SUMMARY OF THE ACTION

AMENDMENTS TO THE SPECIFICATION
Pursuant to 37 CFR §1.121

Patent Application Ser. No.: 10/776,325
Response to the Final Office Action dated June 9, 2006

Annotated Sheet

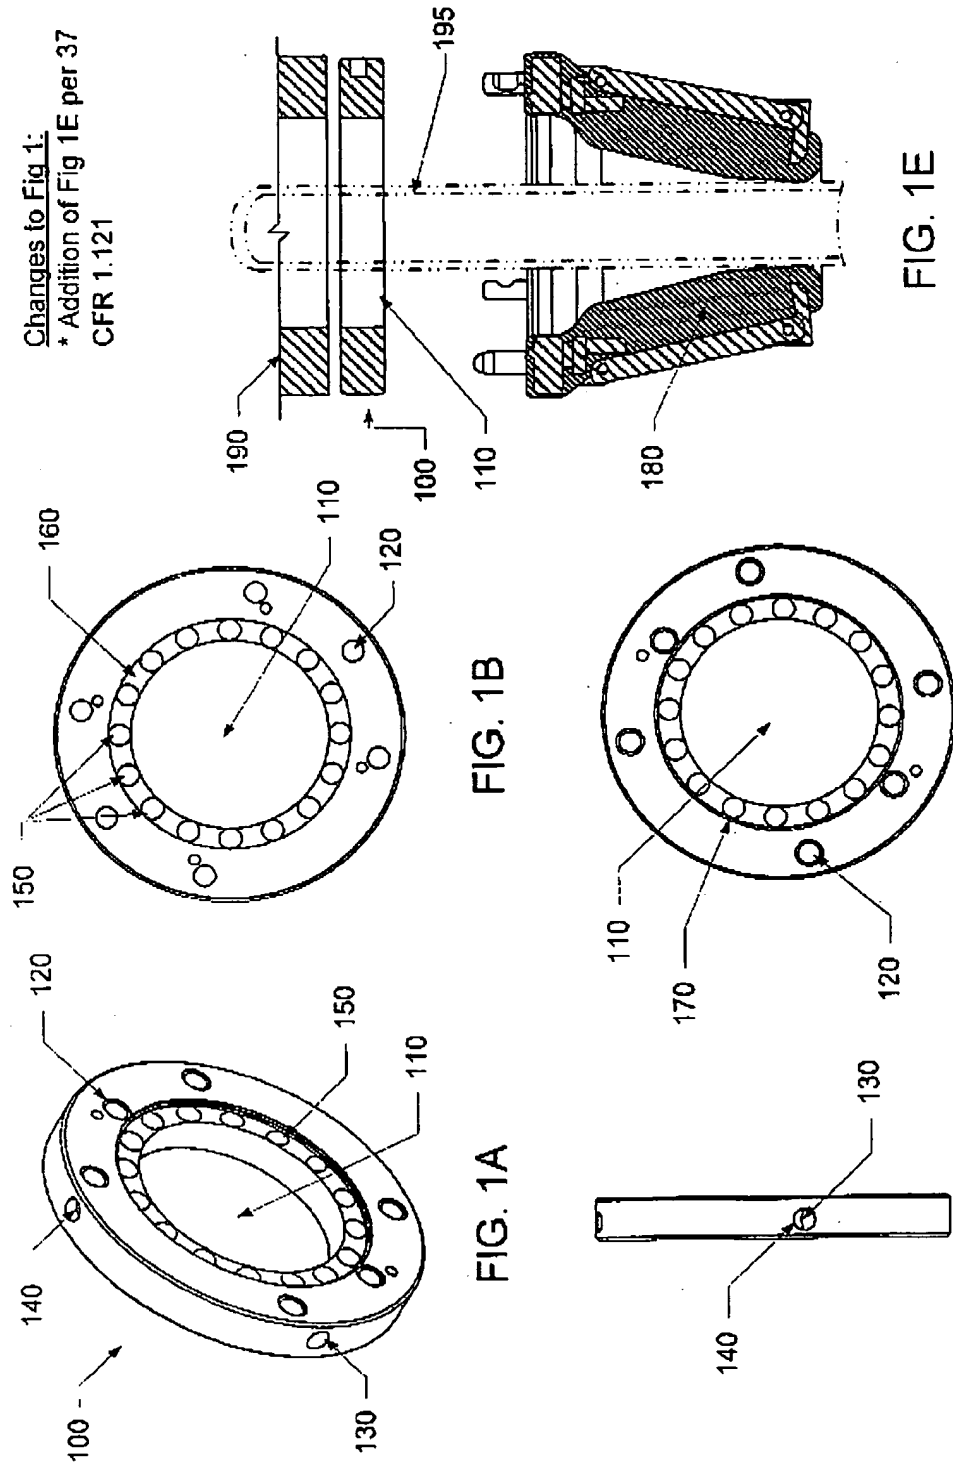
The drawings are objected to by the Examiner under 37 C.F.R. 1.83(a). Corrected drawings are required that show the stripper rubber, drilling head equipment and the down hole tubular. The objection to the drawings will not be held in abeyance and no new subject matter should be entered.

A replacement drawing sheet and an annotated drawing sheet for Figure 1 are submitted herewith to overcome the objection to the drawings. No new subject matter has been entered. Entry after final of the corrected drawing is respectfully requested.

Corrected Figure 1 includes Fig. 1E which shows adapter 100 together with the stripper rubber, the drilling head equipment and the down hole tubular.

Changes to Fig. 1:
* Addition of Fig 1E per 37
CFR 1.121
